## REPORT TO THE DEVELOPMENT REVIEW COMMITTEE

Consideration of a Tentative Parcel Map (TPM 2024-02) and Site Plan Review (SPR 2024-18) proposing to subdivide and partially develop  $\pm 5.47$  acres of property located on the west side of Madera Avenue between Gary Lane and West Pecan Avenue (APN: 012-320-008).

PRELIMINARY IMPROVEMENT PLANS FOR  
**AUTOZONE STORE #1132**  
 SOUTH MADERA AVE (HWY 145)  
 MADERA, CA 93637  
 APNs: 012-320-008-000

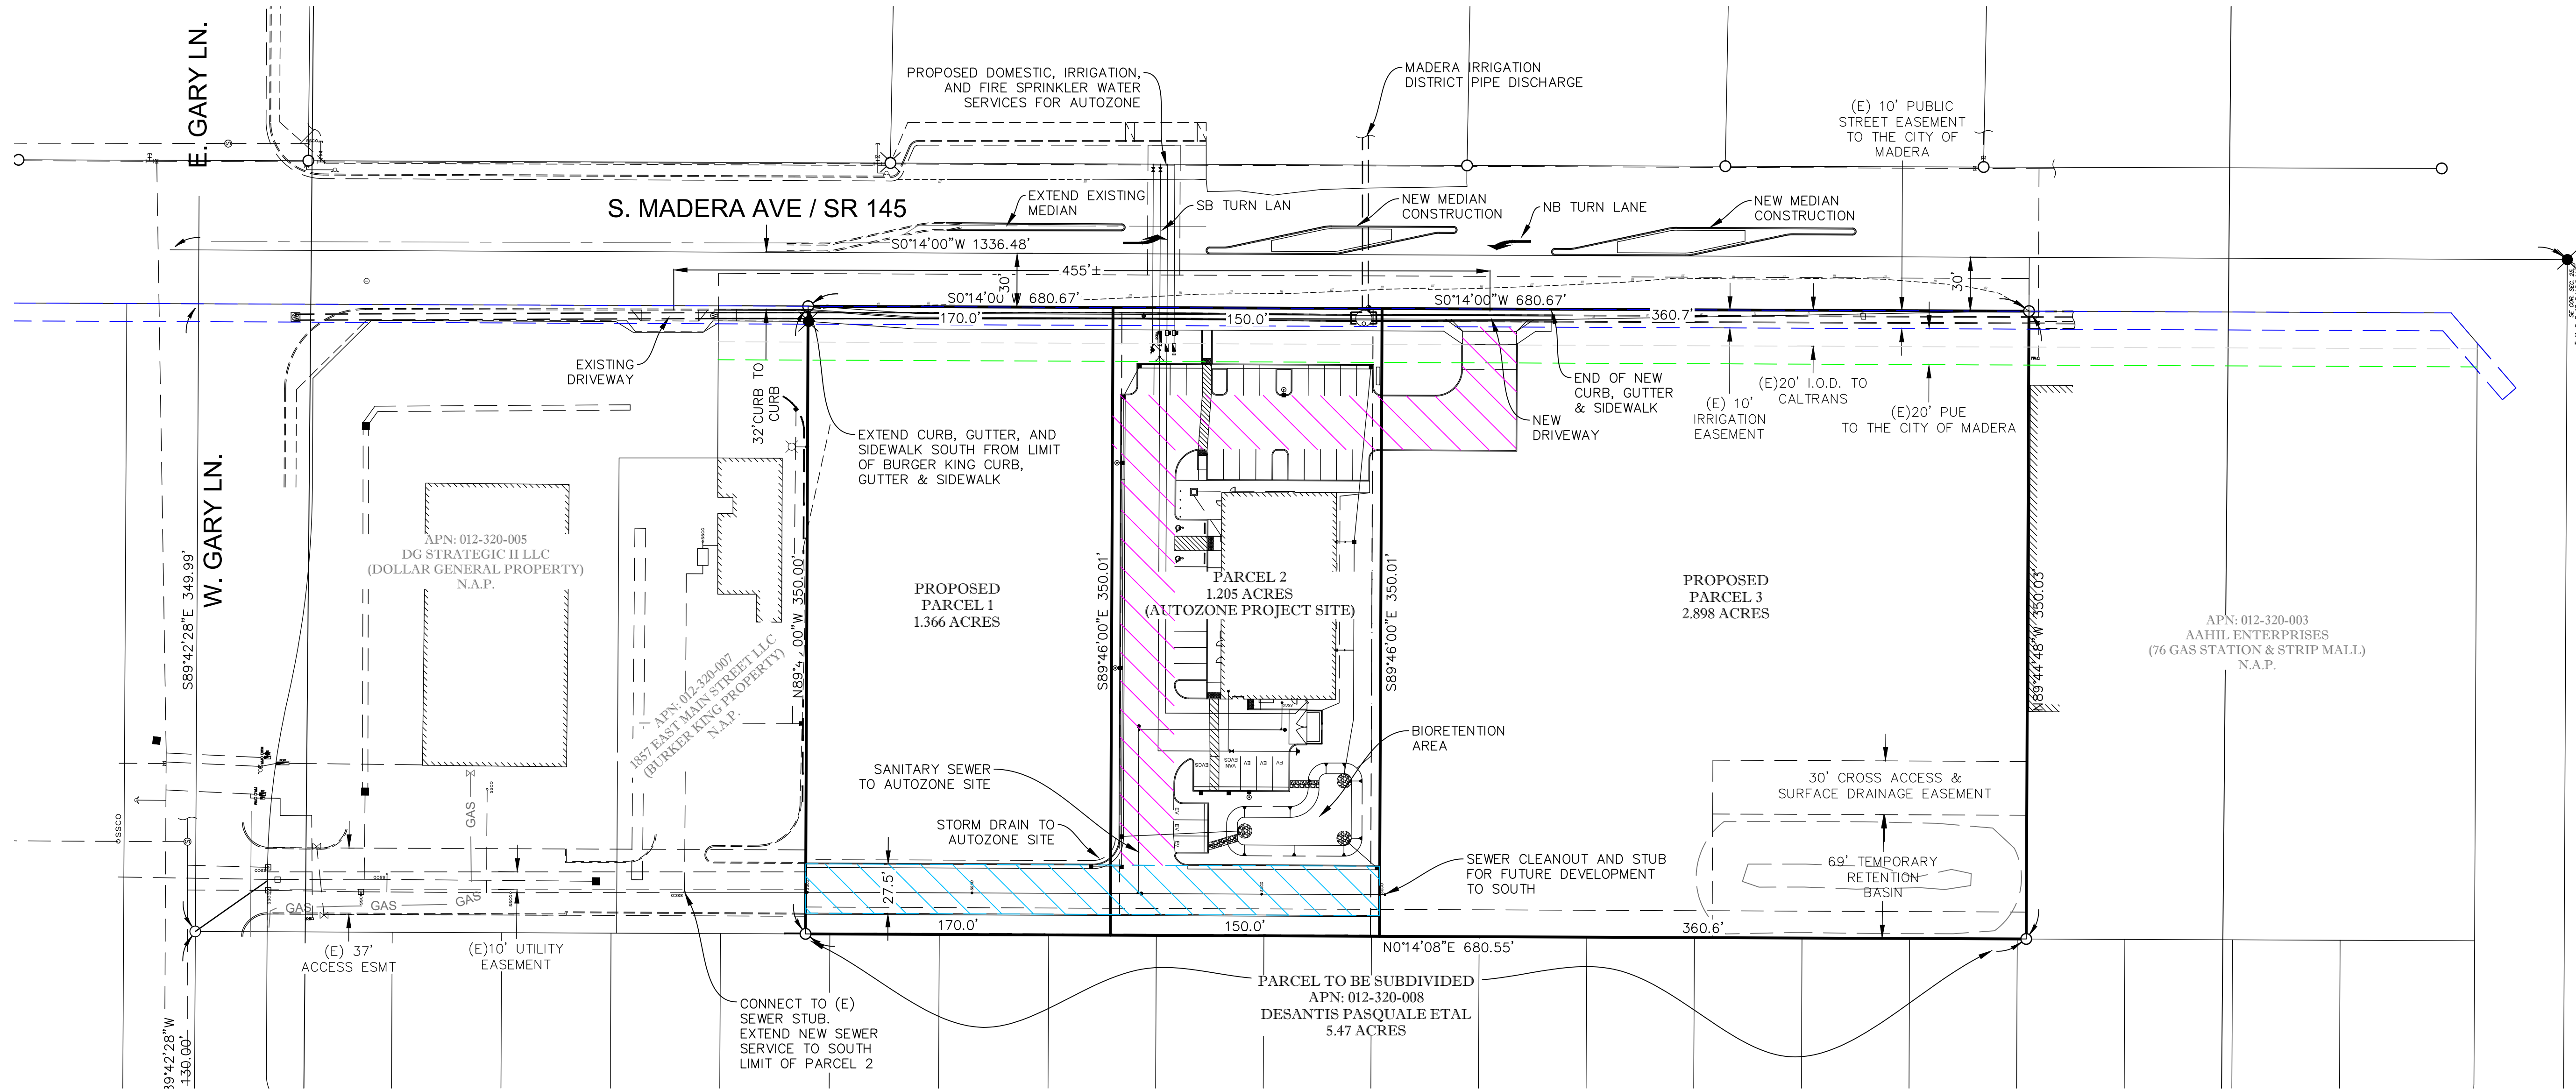
1. The site plan (sheet C1) appears to indicate 30 feet distance, from the edge of the existing southbound (SB) median left turn channelization to the new curb and sidewalk on the development side.

2. The site plan (sheet C1) proposes the new traffic diverters in the median, one is to modify the existing southbound (SB) left turn channelization and the other is the new northbound (NB) left turn pocket onto the development. The length of both left turn channelization appears short. We request that the length of both left turn channelization be extended as long as possible, especially for the NB left turn pocket. As a minimum, the length of the NBLT pocket should be extended to the end of the property (or parcel 3). This is to minimize the left turn queue spill out to the mainline through lane during peak hours. Please note that Caltrans Highway Design Manual (HDM) Index 405.2 specifies the requirement length for turn lanes. Please refer to the HDM for guidance.

Sheet  
**C2**  
 2 of 5  
 8/28/2024

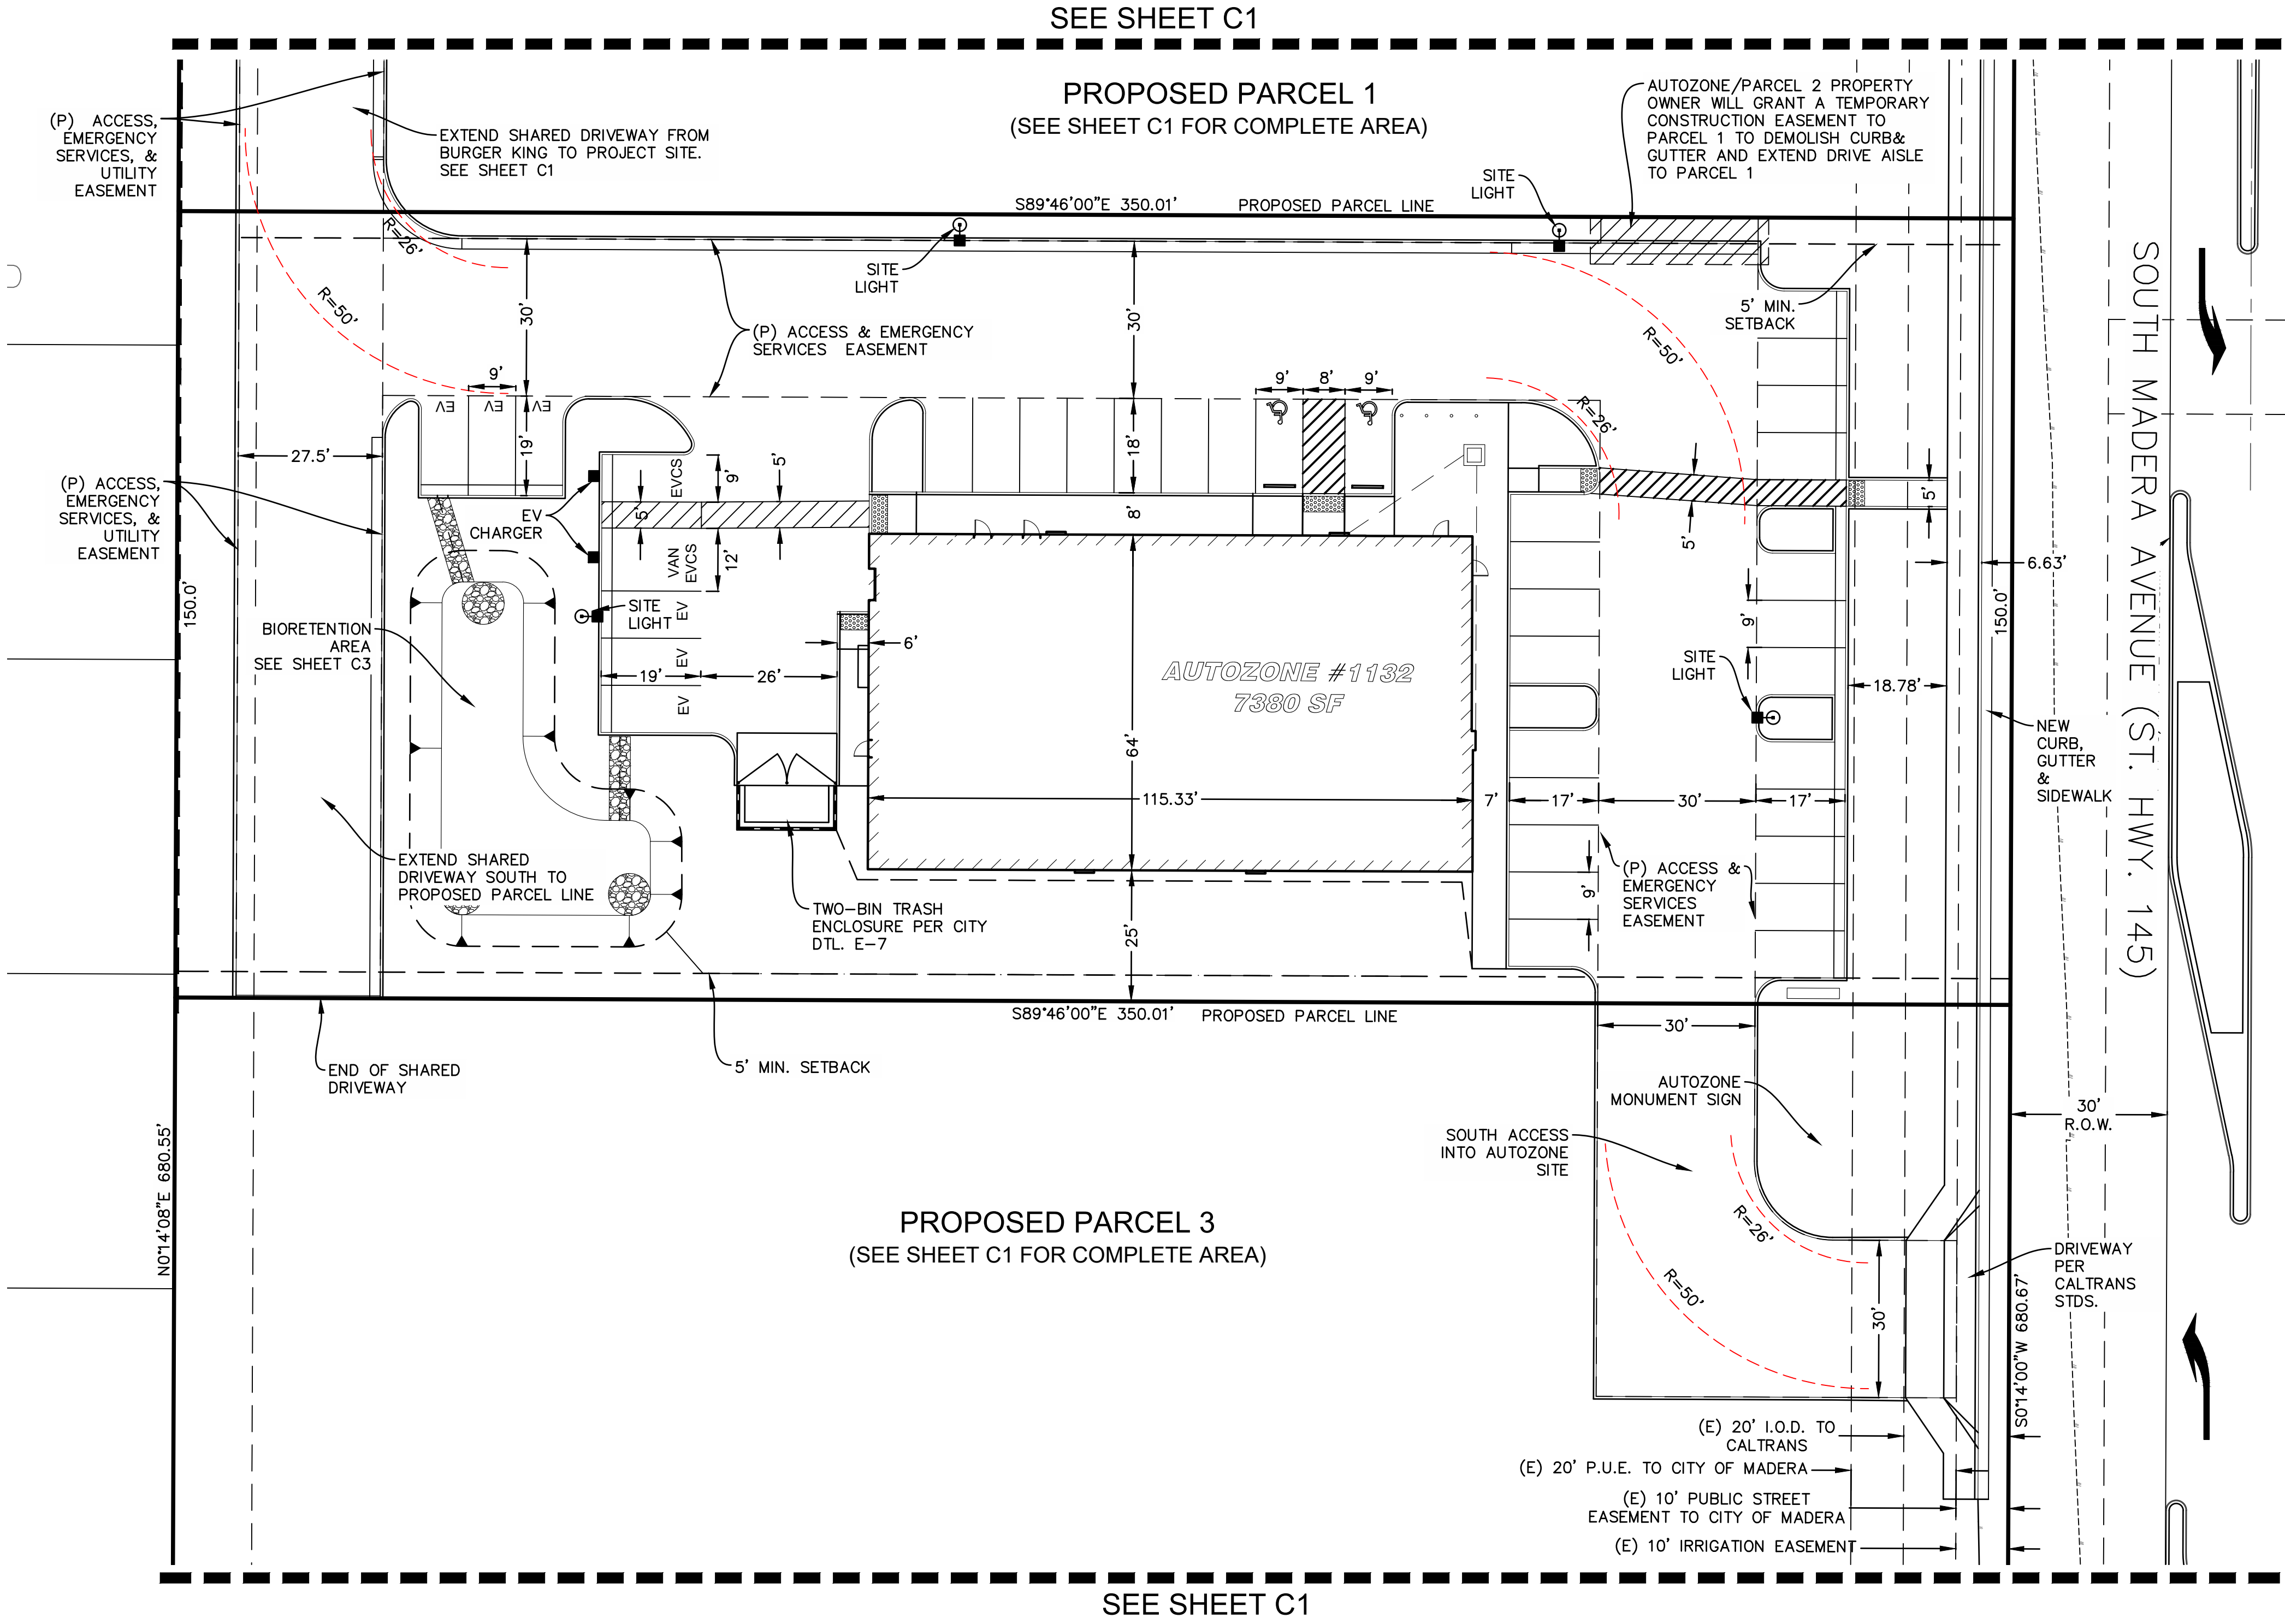
The site plan did not provide the distance from centerline to the new right-of-way line. It is estimated that approximately 52 feet is needed to achieve the four-lane configuration, if existing centerline is in the center of the highway. As a minimum, the new right-of-way (including sidewalk and curbs) shall be aligned with the property in the north (Burger King Restaurant and DG Market).

Sheet  
**C4**  
5 of 5  
8/28/2024

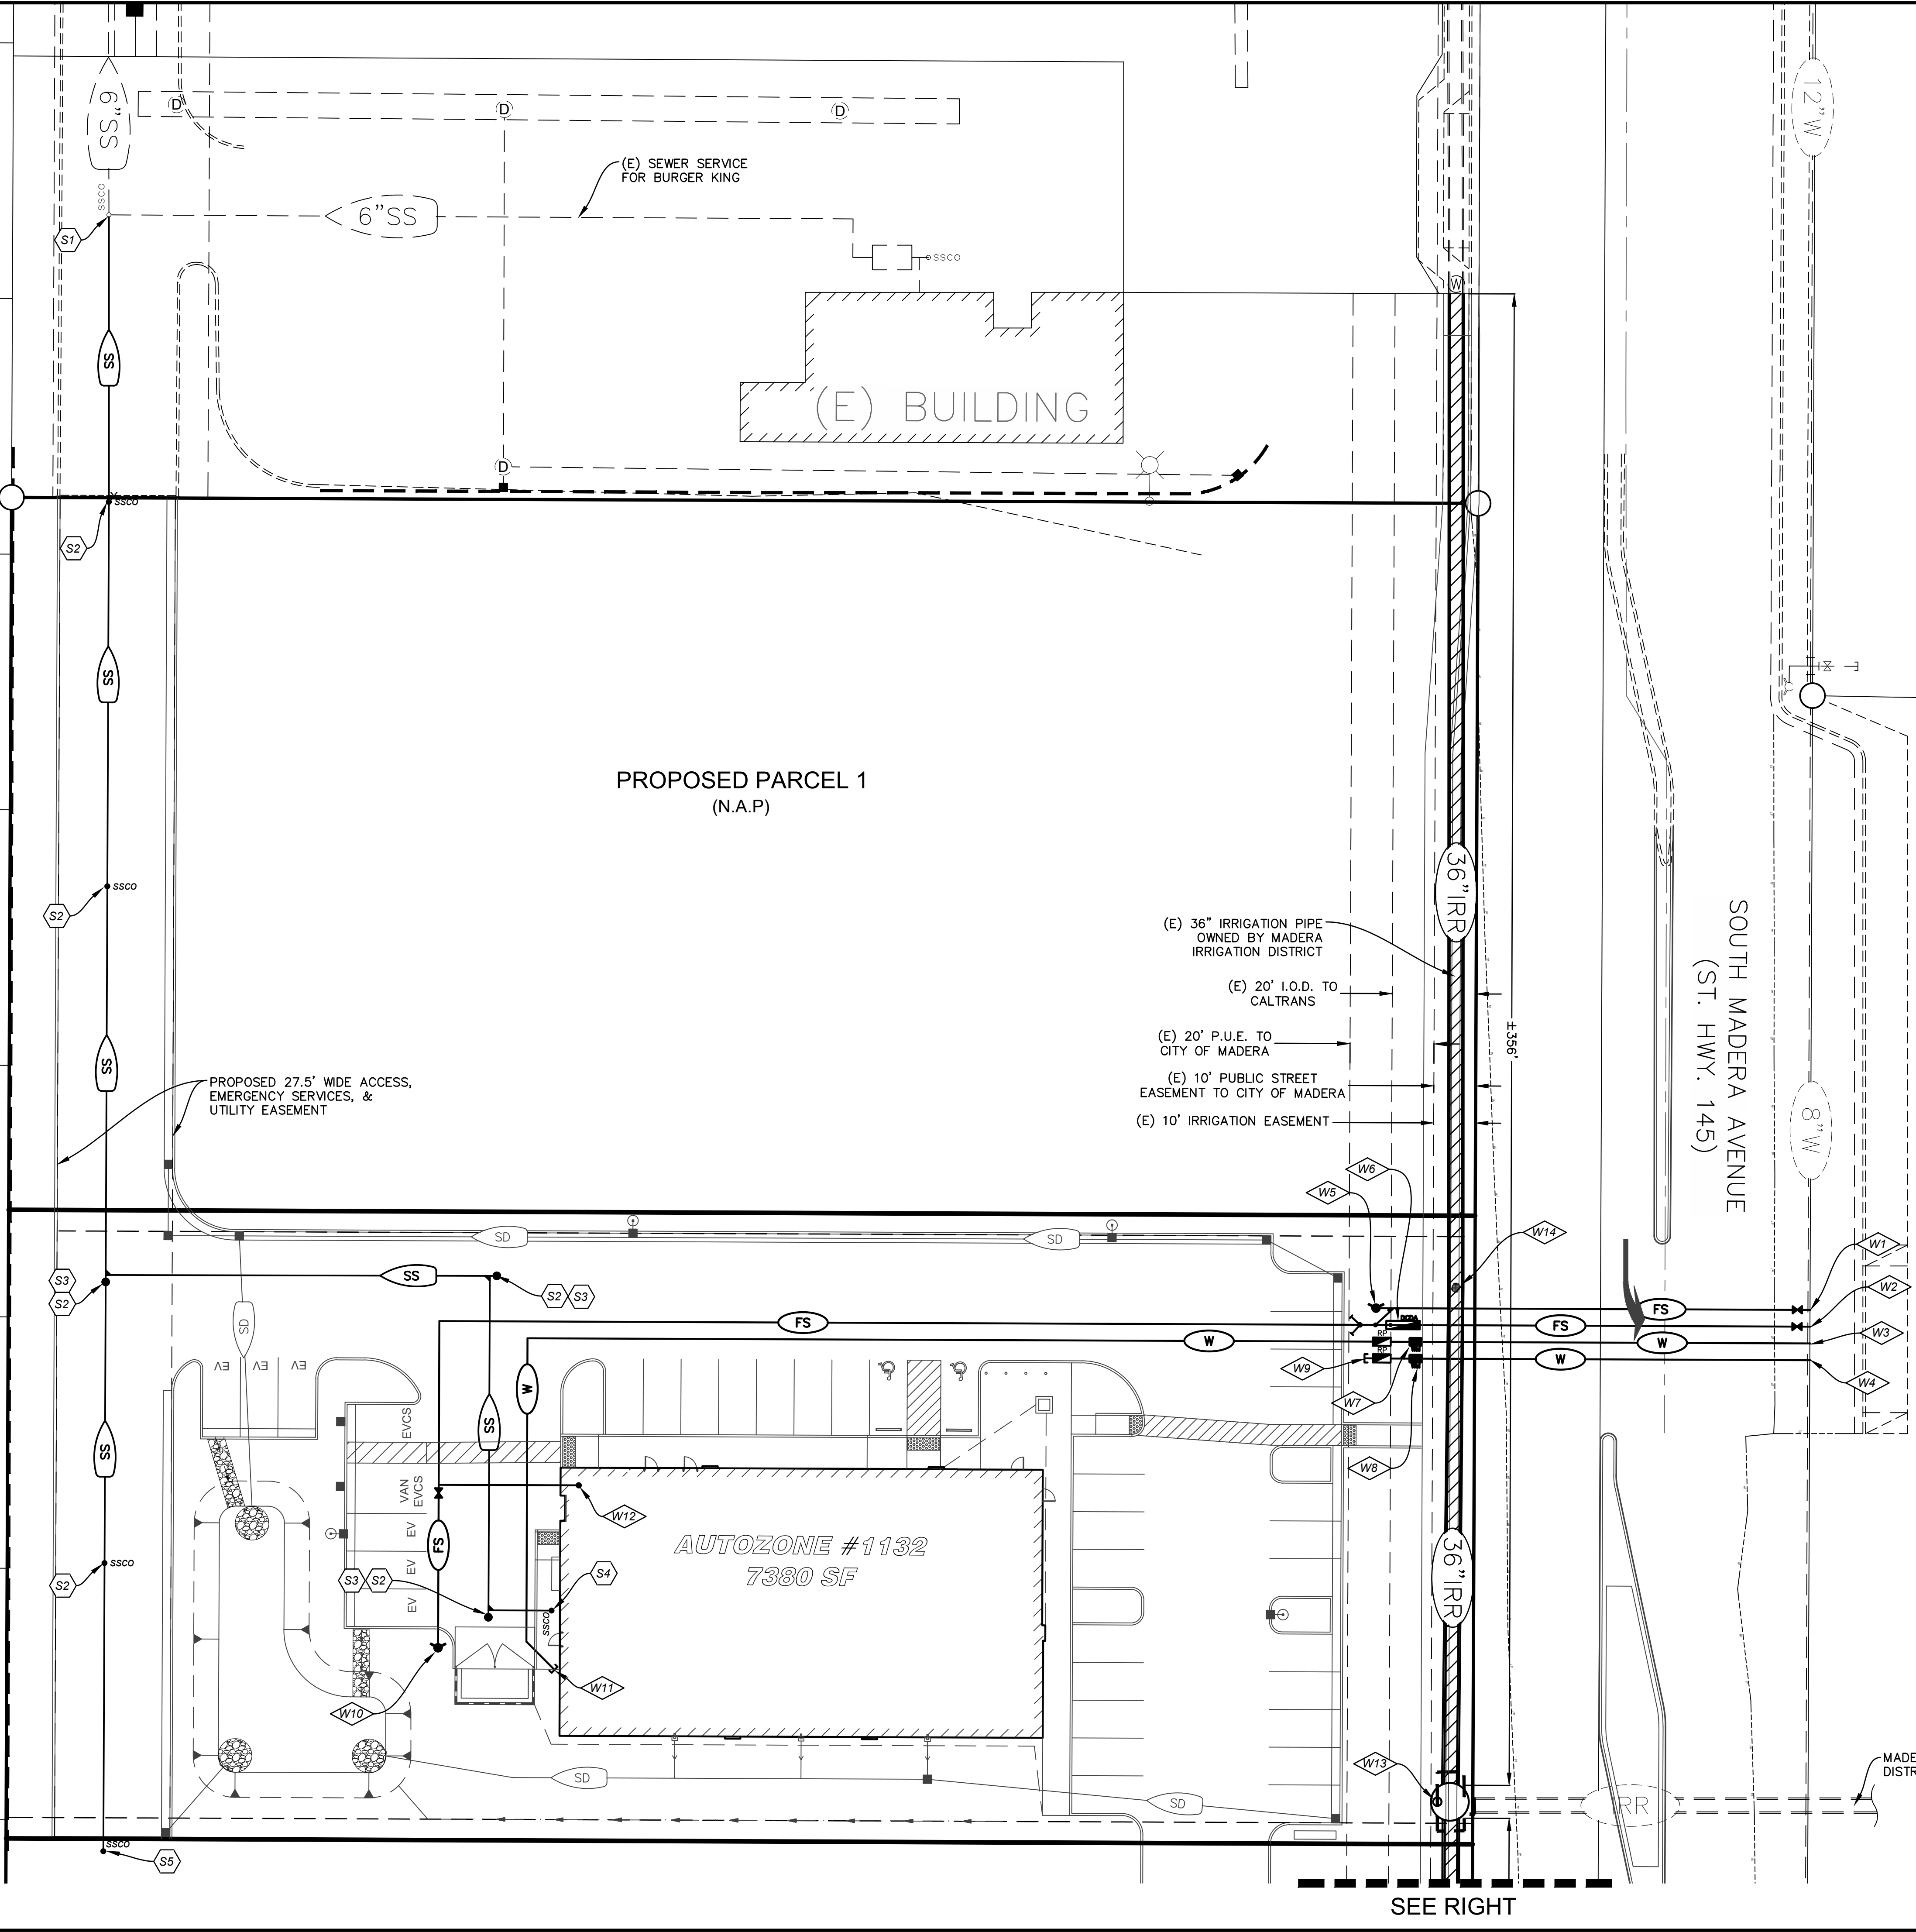
64. Madera Irrigation District (MID) has 36" cast-in-place pipeline along the east property line. The applicant shall be required to replace the pipeline within Parcel 1 and Parcel 2 prior to any development.
